ADDENDUM

Date Issued:	April 8, 2019
Project:	Intermountain Healthcare IMC- Cath Lab #6 Remodel 5121 South Cottonwood Street Murray, Utah 84107
Addendum Number:	1

ADDENDUM #1

PROJECT: IMC Bldg 5 L1 Cath Lab #6 Remodel

2 LEVEL 1 LIGHTING PLAN
SCALE: 1/4" = 1'-0"

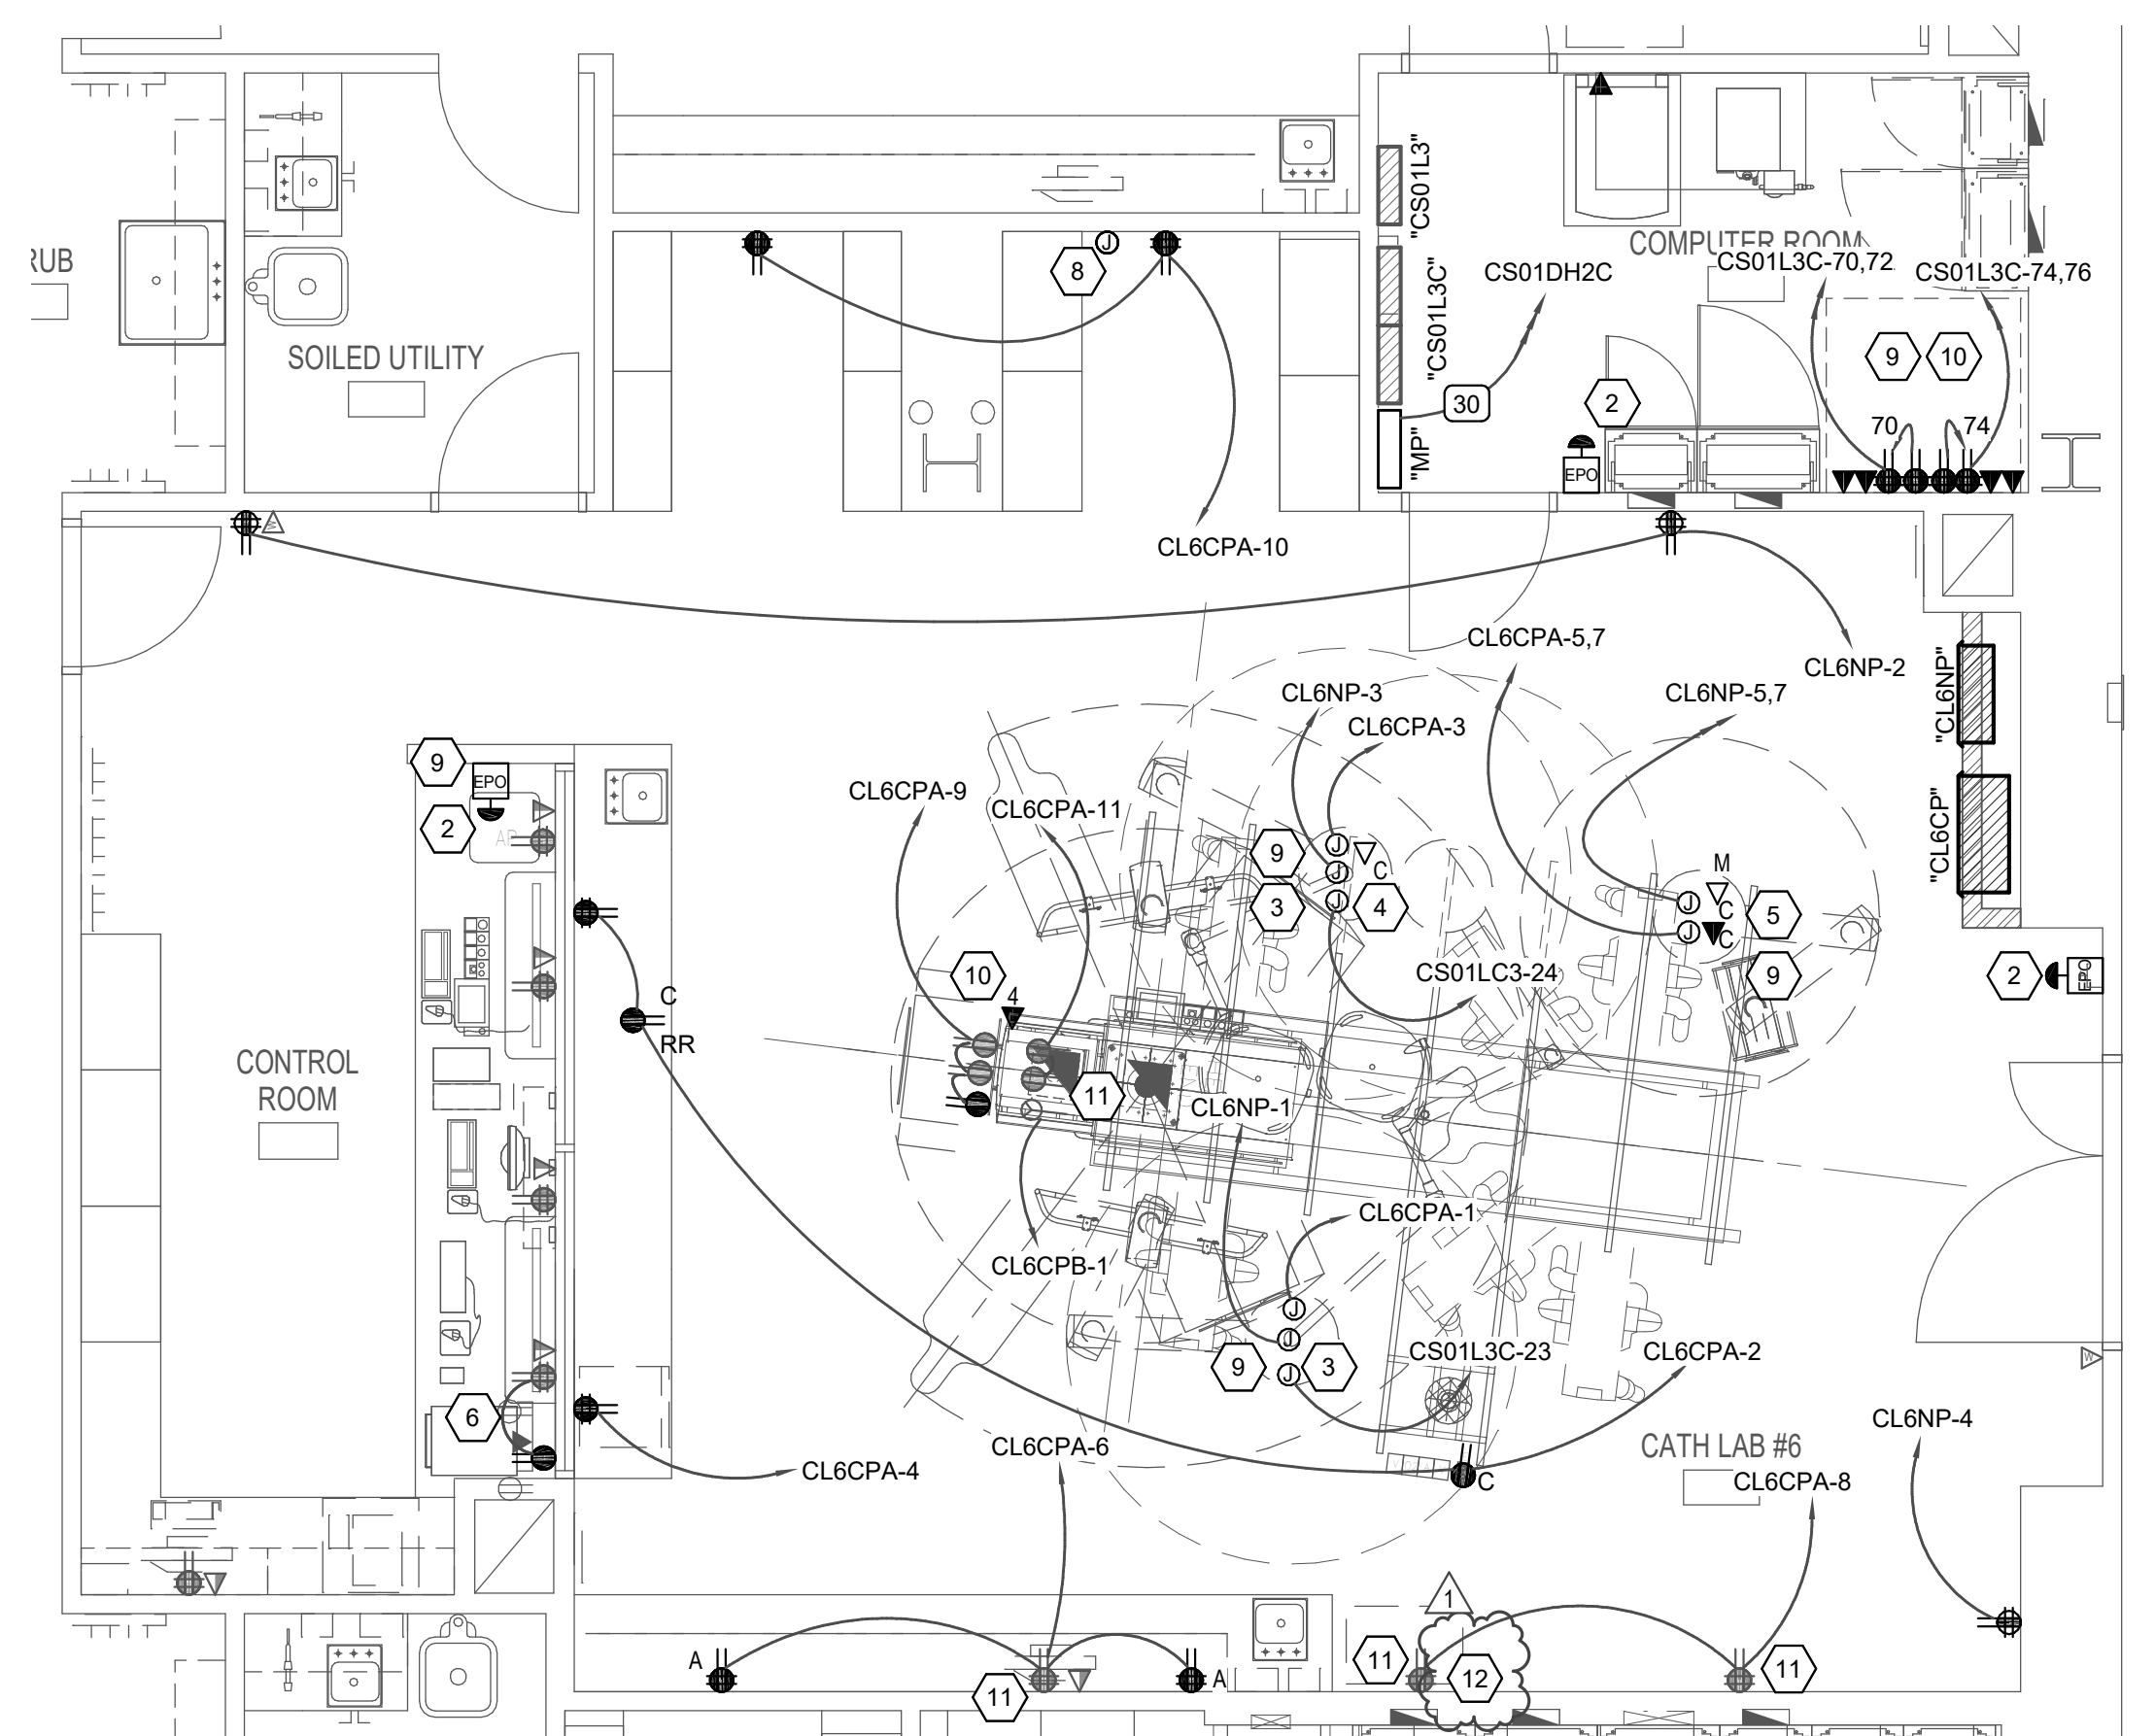
1. Detail #1: Added conduit and data cable for video switch. (Keynote #12)
2. Detail #2: Revised lighting to match existing light locations and removed one can light.
3. Detail #3: Revised existing light locations and removed one can light.
